### REMARKS

Applicant : Dae Hyun Cho et al.  
Serial No. : 10/825,070  
Filed : April 15, 2004  
Page : 12 of 12

Attorney's Docket No.: 14245-004001 / FP2004-  
0001/US

FIG 3

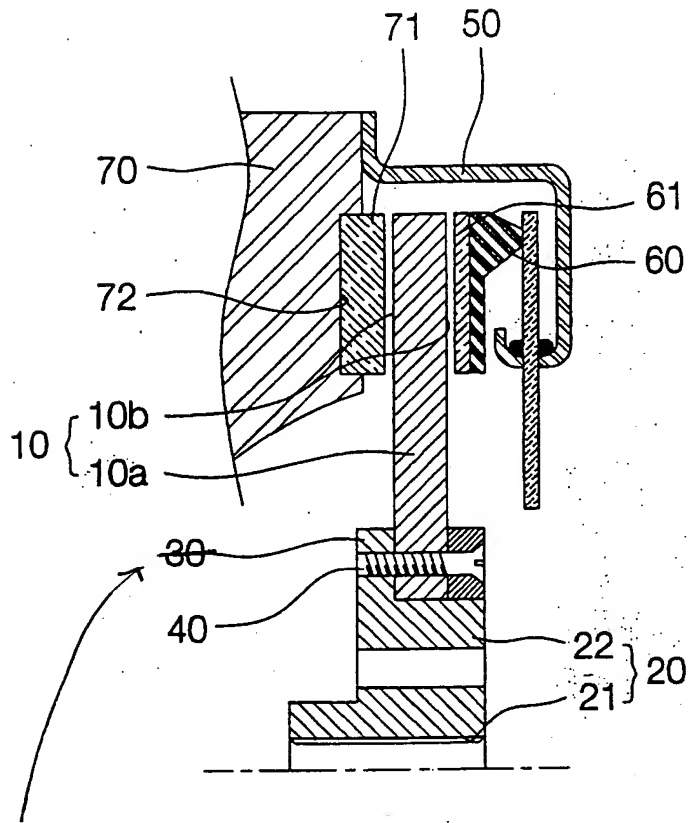
In Figure 3, reference numeral "30" has been deleted.

*delete reference numeral "30"*
